FIRE SAFETY INSPECTION REPORT

RHINE DRESS LTD.

ACCORD
on Fire and Building Safety in Bangladesh

July 8, 2014

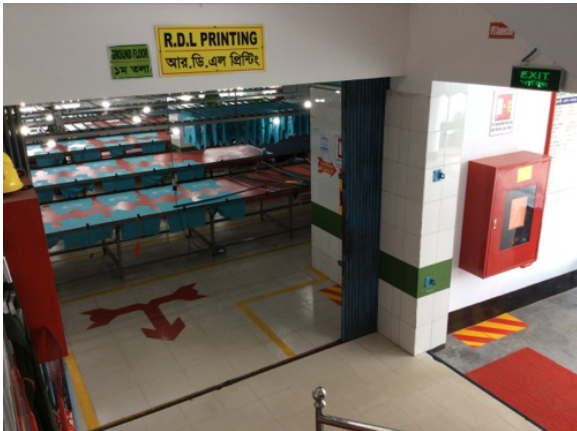
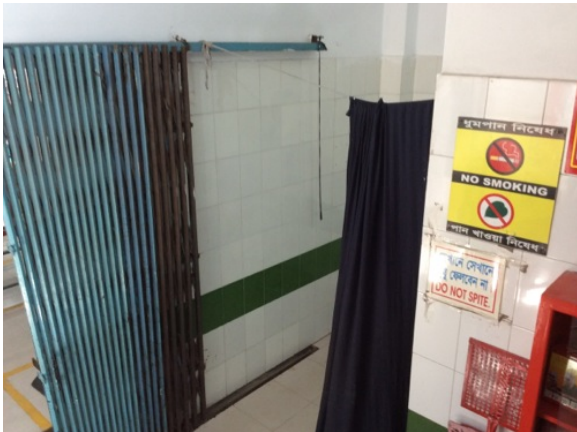
F-2	Fire Rated Construction	The exit stairs are not separated from work areas on each floor by fire-rated construction.	Provide minimum 1.5-hr fire rated doors and seal all unprotected openings to separate the exit stairs from work areas on all floor levels. Ensure that the fire doors are self-closing and positive latching and that they are provided with fire exit (panic) hardware where serving production floors.	Within 3 months
-----	-------------------------	---	--	-----------------

If fire doors are required to be held open for functional reasons, provide automatic-closing devices tied to the fire alarm system.
